Product Change Notification

113327 - 00

Change Notification #: 113327 - 00
Change Title: Intel® Server System R2312GZ4GS9
PCN 113327-00, Product Design
Update the System Rear Panel, 750W Common
Redundant Power Supply Firmware, Resistors
and Capacitor
Date of Publication: October 22, 2014

Figure One

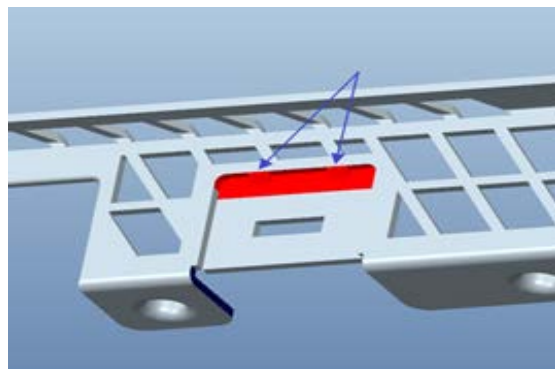
1. Update the one big center joint to two smaller joints so that the joints will not conflict with the LAN cable connector latch. See Figure One.

Figure Two

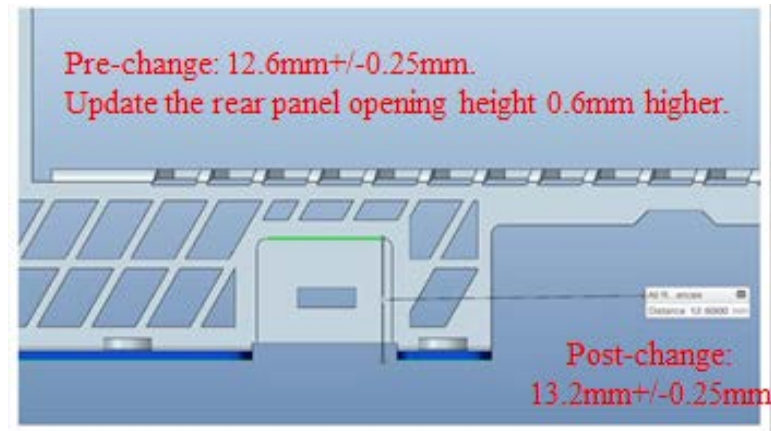
2. Update the rear panel opening height 0.6mm higher to improve the flexibility for the cable latch. The previous height was 12.6mm \pm 0.25mm. The updated height is 13.2mm \pm 0.25mm. See Figure Two.

Figure Three

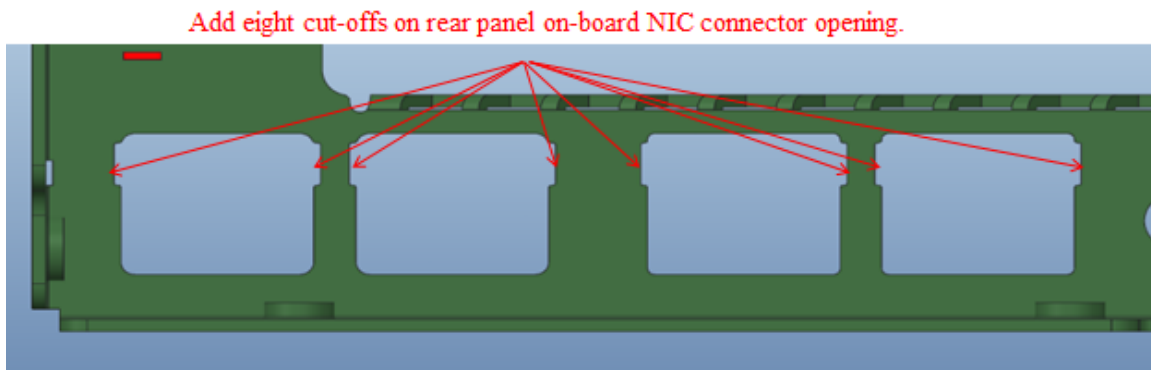
3. Add eight cut-offs around the on-board NIC (Network Interface Controller) openings to improve the LED visibility. See Figure Three.

Figure Four. Component Locations for the 2U Riser Spare A2UL8RISER

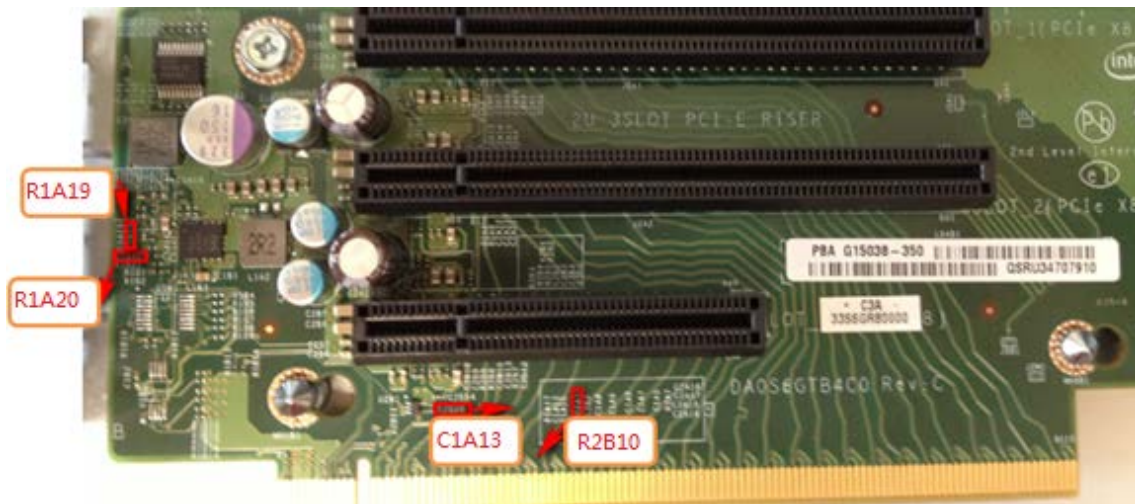
- Update the following resistors and capacitor (see Table One and Figure Four) on the 2U PCIe Riser Spare A2UL8RISER to make an improvement to support a higher 3.3 Voltage Regulator startup over current. Before this change, the Voltage Regulator on the riser card may not be able to turn on when the total current drawn is more than 5A current. After this change, the Voltage Regulator on the riser card can support more than 10A current.
